CITY OF PORTLAND

BUILDING PERMIT

Job ID: 2012-05-4092-ALTCOMM

has permission to Construct a 12'x20' loading dock & 24'x6'4" concrete vehicle ramp on existing building, re-build adj..steps provided that the person or persons, firm or corporation accepting this permit shall comply with all of the provisions of the Statues of Maine and of the Ordinances of the City of Portland regulating the construction, maintenance and use of the buildings and structures, and of the application on file in the department.

Entry Stairs

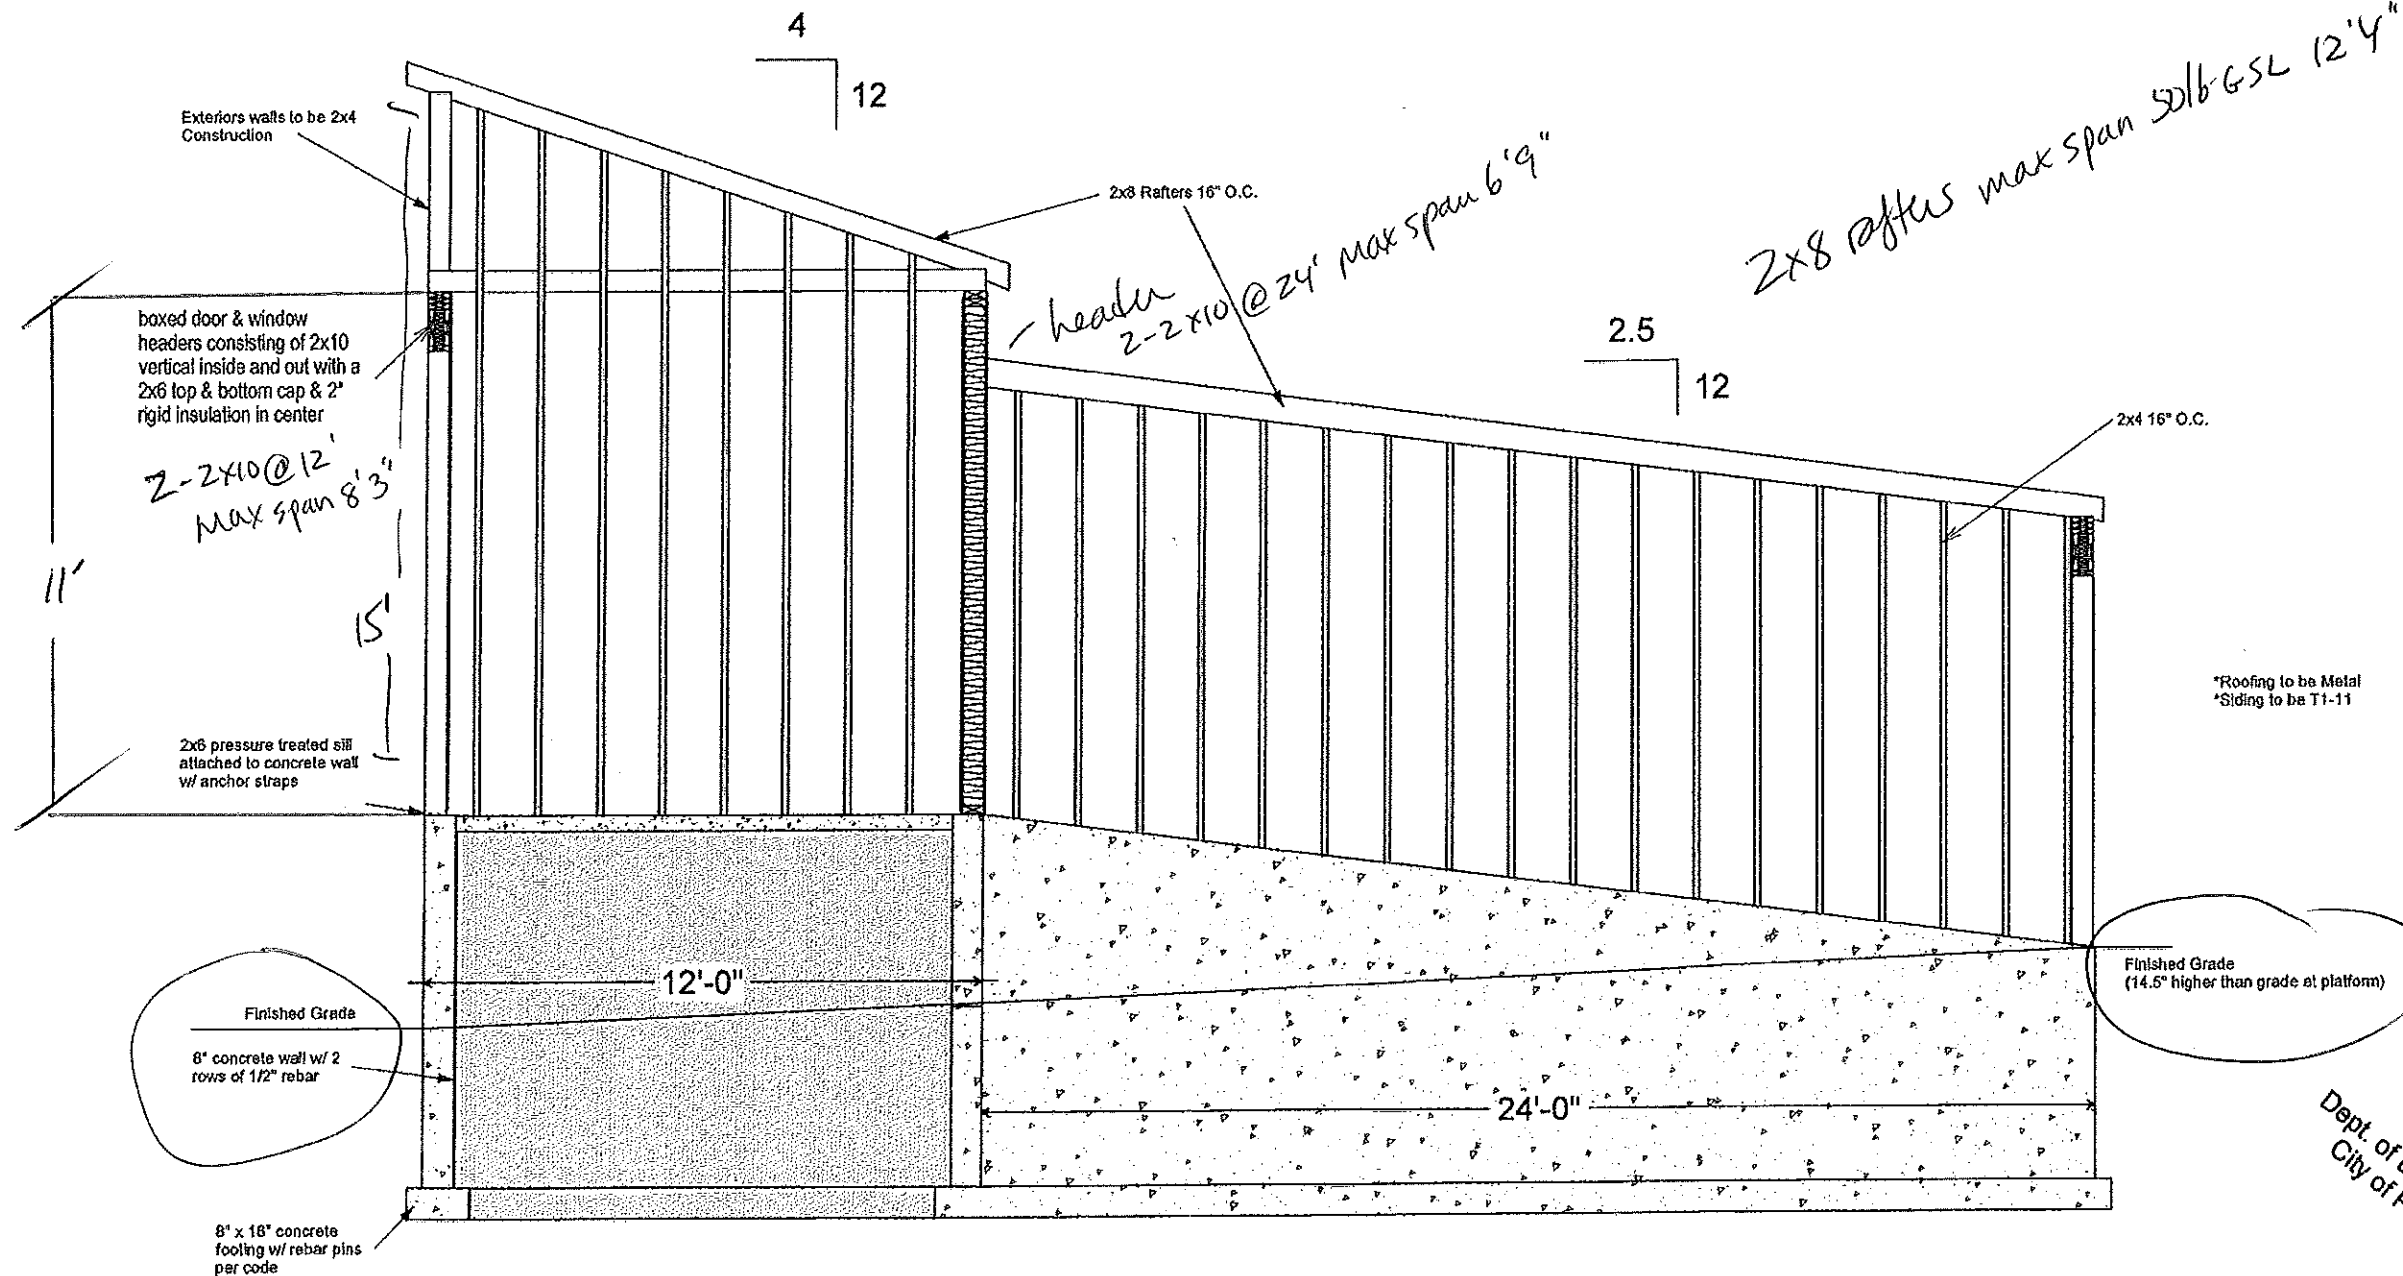
I would like the description labels to be complete...it is not clear what some say...
Thanks

Not to be picky Mark, but the descriptions are broken up.
Jeanie

If the stair is exiting from the industrial area, the toe kick is allowed up to 7". Graspable hand rails are always required on both sides of stairs with returns at 34"-38", with few exceptions.

Just remember the tread dimension is measured from tread nose to tread nose.

1. This is labeled as Plasmine Office Building, so is this business use or industrial? Reason being is that the landing is required to be at the level of the floor with some exceptions based on use, and business is not one of them.
2. The net tread is required to be 11" with no nosing projection, 90 degrees to the riser or an angled riser so an 11" seat cut.
3. Can you please provide more detail on the framing, ie. cross section showing beam size and bearing detail, joists and connectors.
4. Is the top rail on the stairs graspable and will there be another handrail on the wall?

I am not sure how you classify the use of this stairway, it is attached the warehouse/storage area of the office building. I would consider that industrial, no customers will be using this set of stair; it will be employee only entrance. The reason we had left the toe kick is because that is what they requested, but if we need to make it flush for code we will. Please let me know on that.

We were planning on using a 2x4 railing. I guess that is not considered "graspable" but we did not have plans of putting in a second rail. Again if we need to add a graspable rail, just let me know and we will.

I will have our architect draw the framing details and cross section and get that back to you. We can also make the total tread depth 11".

**Elevations &
Perspectives**

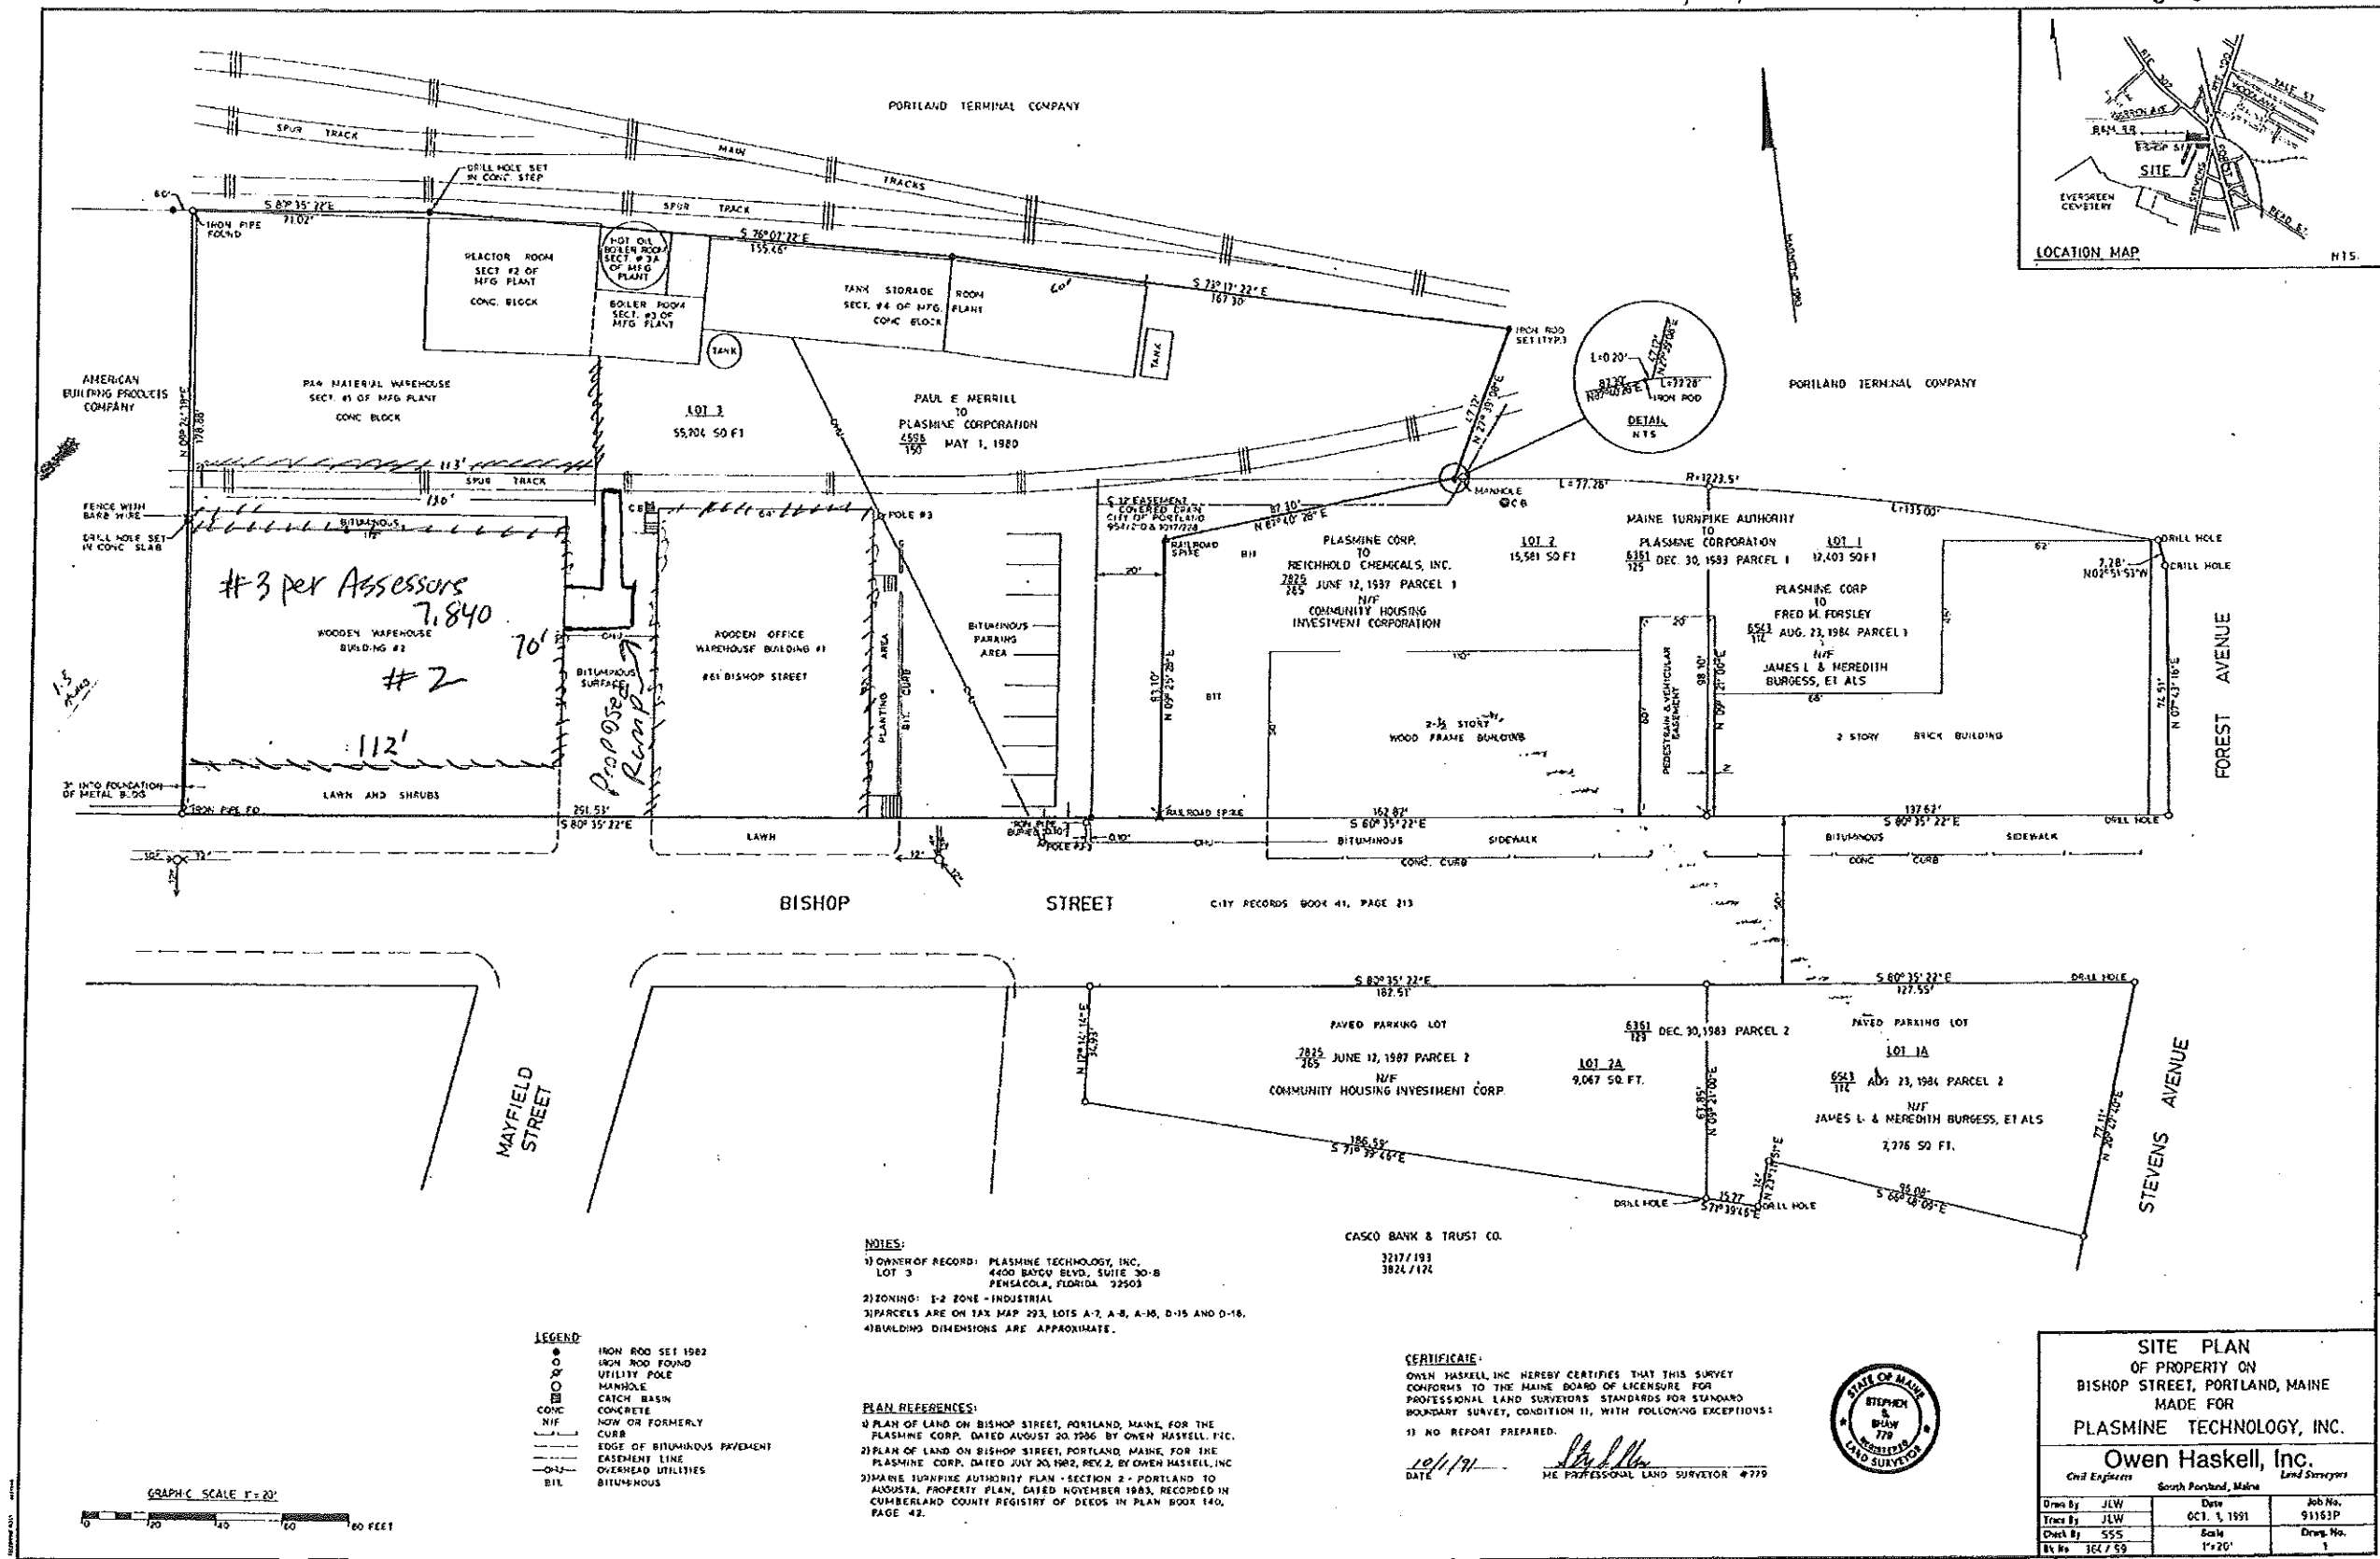
IM zone - Impervious 75% - ramp on paved surface (OK)
 Sidewalk N/A
 cur. N/A
 front - 1' for each foot of building height - 25kies > 35 set back (OK)

SITE PLAN
 OF PROPERTY ON
 BISHOP STREET, PORTLAND, MAINE
 MADE FOR
 PLASMINE TECHNOLOGY, INC.

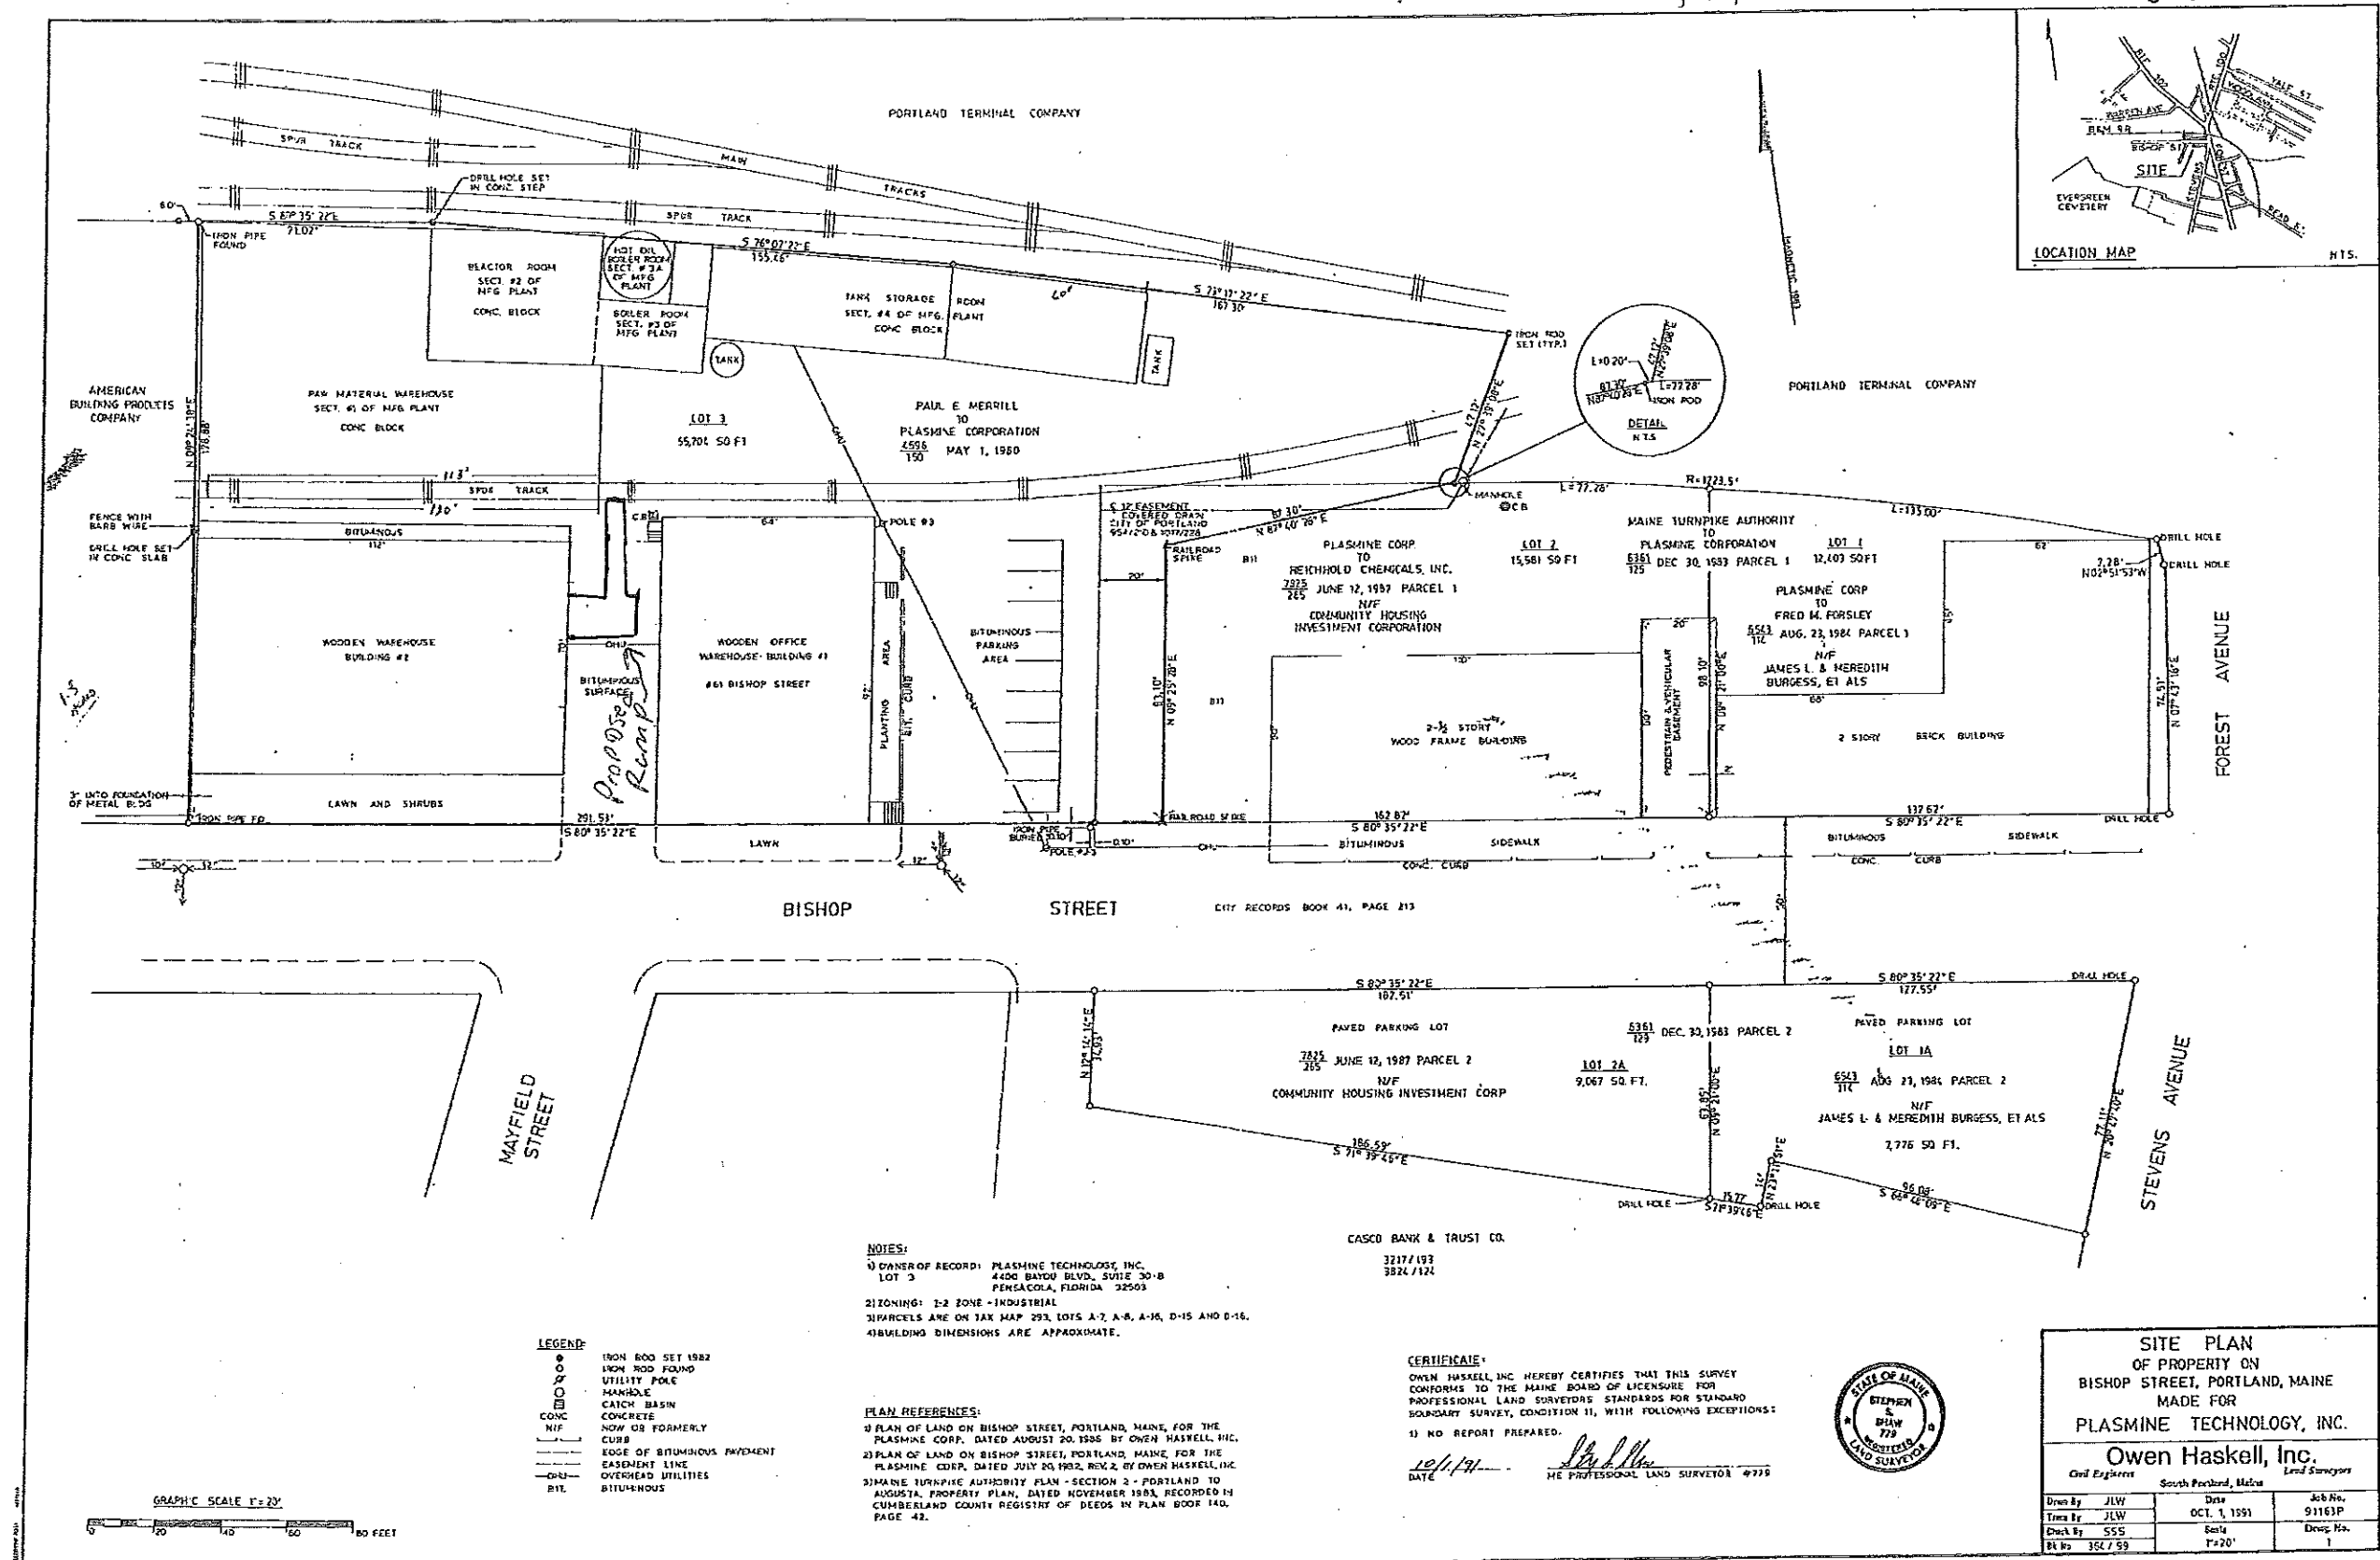
IM zone - Impervious 75% - ramp on paved surface (circled)
 Sides 1/4
 rear 1/4
 front - 1' for each foot of building height - 25 stairs > 35 set back (circled)
